Safety Defect and Noncompliance Report Guide for Vehicles **Part 573 Defect and Noncompliance Report**

The manufacturer's identification number for this recall is **07V-363**

RECALL SERVICE BULLETIN

SUBJECT: Power Distribution – Bussmann® (DVEC) Dual Vehicle Electrical Center.

FIG. 2-1

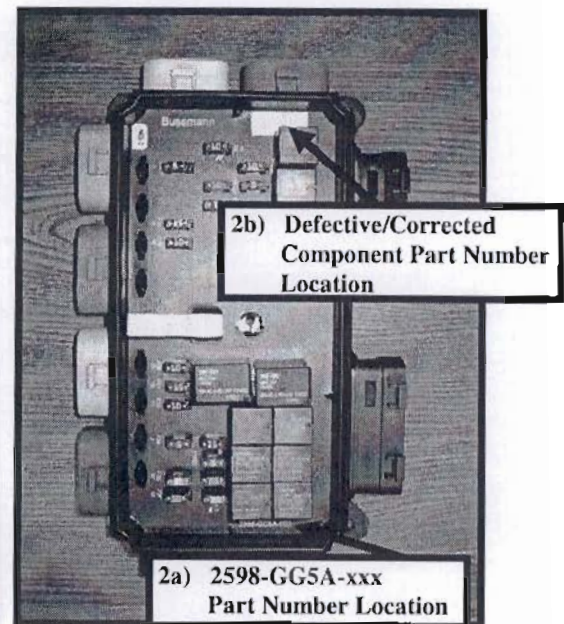
1. Observe all industry safety standards, disconnect any necessary power source and secure vehicle to allow for replacement of the Bussmann® DVEC at the rear PDC (Power Distribution Center).
2. Locate the rear PDC near the engine, generally on the passenger side between the rear wheels and the rear of the vehicle.
 - 2a. Refer to FIG. 2-1. Identify the DVEC having a part number beginning with 2598-GG5A. The part number is located on the inside cover and on the lower right inside face of the box.
 - 2b. Refer to FIG. 2-1, 2-2 & 3-1. The DVEC having a part number in the top right corner of the box ending in a -1 is defective and must be replaced with a box where this number ends in -2 as shown in FIG. 3-1.

CORRECTION: Replace Bussmann® DVEC.

FIG. 3-1

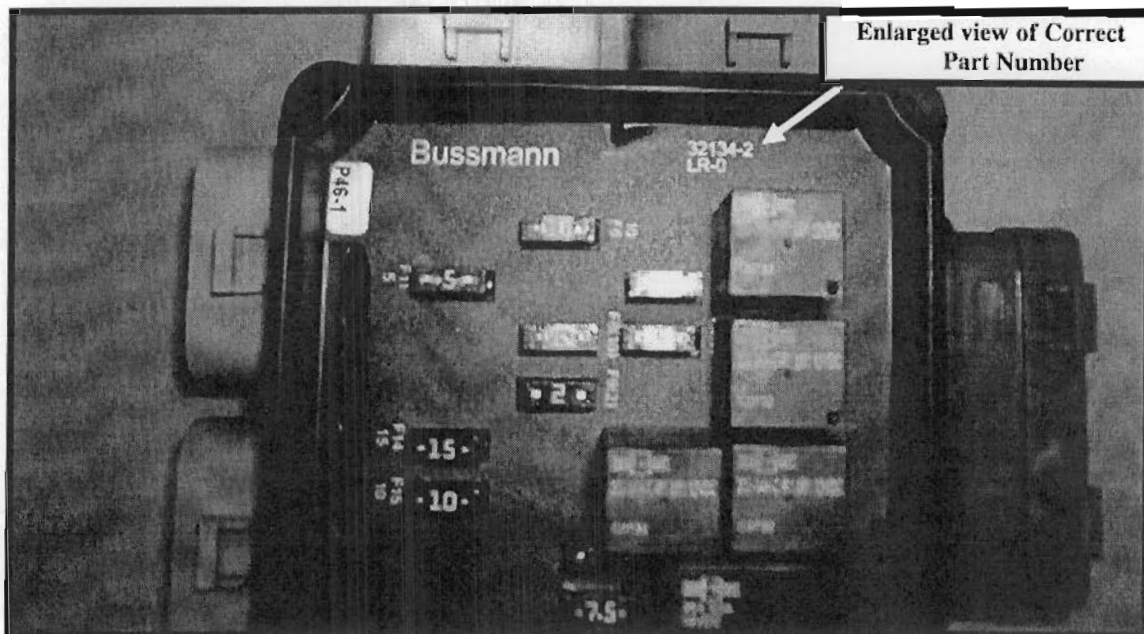
CORRECT BUSSMANN® DVEC SHOWN

3. Disconnect the electrical connectors to the DVEC and remove the 4 fasteners attaching the DVEC to the mounting surface. Retain mounting fasteners for reinstallation. Replaced DVEC must be returned to Spartan Chassis Inc.

4. Attach the DVEC to the mounting surface using the fasteners removed in step #3.
5. Connect electrical connectors to the new DVEC.
6. Reconnect any power source previously disconnected.
